Access Compliance Report

Public Rights-of-Way

Intersection ID: 16483	Main Street: QUEENS_RD	Cross Street: RADCLIFFE_AV	Location: E
ADA ID: 7098106745CA	Ramp Type: MedianPerp	Initial Pass/Fail: Fail	Overall Compliance: No
Severity Score: 33.75			
Codes/Mitigation Info/Possible Solution		Field Measurements/Component Compliance

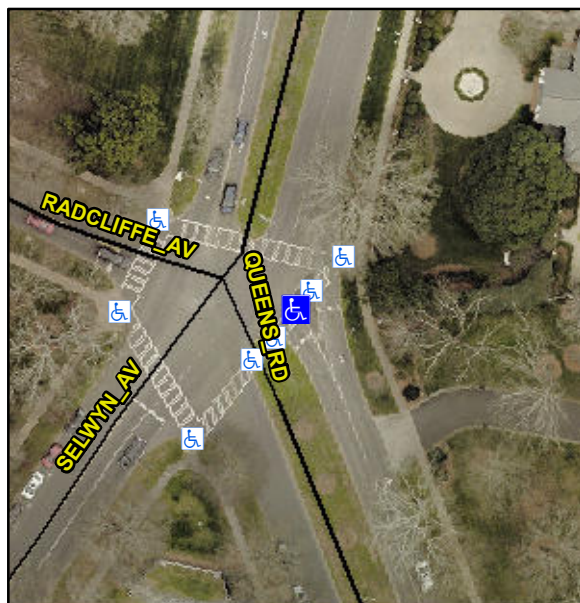
Not Found, R304.5.1, R304.5.3

Compliance	Description	Data	Compliance	Description	Data
N/A	Ramp Length (in)	56.0	Yes	Ramp Slope (%)	5.2
No	Ramp Width (in)	46.0	No	Ramp XSlope (%)	7.8
N/A	Flare Type LT	N/A	N/A	Flare Type RT	N/A
N/A	Flare Slope LT (%)	N/A	N/A	Flare Slope RT (%)	N/A
N/A	Flare Traversable LT?	N/A	N/A	Flare Traversable RT?	N/A
N/A	Landing Length (in)	N/A	N/A	DWS Provided?	N/A
N/A	Landing Width (in)	N/A	N/A	DWS Contrast?	N/A
N/A	Landing Slope (%)	N/A	N/A	DWS Length (in)	N/A
N/A	Landing X Slope (%)	N/A	N/A	DWS Full Width?	N/A
N/A	Landing Curb? (Y/N)	N/A	N/A	DWS Offset (in)	N/A
N/A	Shared Landing?	N/A			
N/A	Gutter Ponding?	N/A	N/A	Gutter Slope (%)	N/A
N/A	Gutter Lip Ht (in)	N/A	N/A	Gutter X Slope (%)	N/A
N/A	Painted X Walk1?	Yes	N/A	Painted X Walk2?	N/A
	X Walk 1 Direction	To SW		X Walk 2 Direction	N/A
N/A	X Walk 1 Width (in)	71.0	N/A	X Walk 2 Width (in)	N/A
	X Walk 1 Slope (%)	1.5		X Walk 2 Slope (%)	N/A
	X Walk 1 X Slope (%)	2.6		X Walk 2 X Slope (%)	N/A

Remove & Replace Entire Ramp.
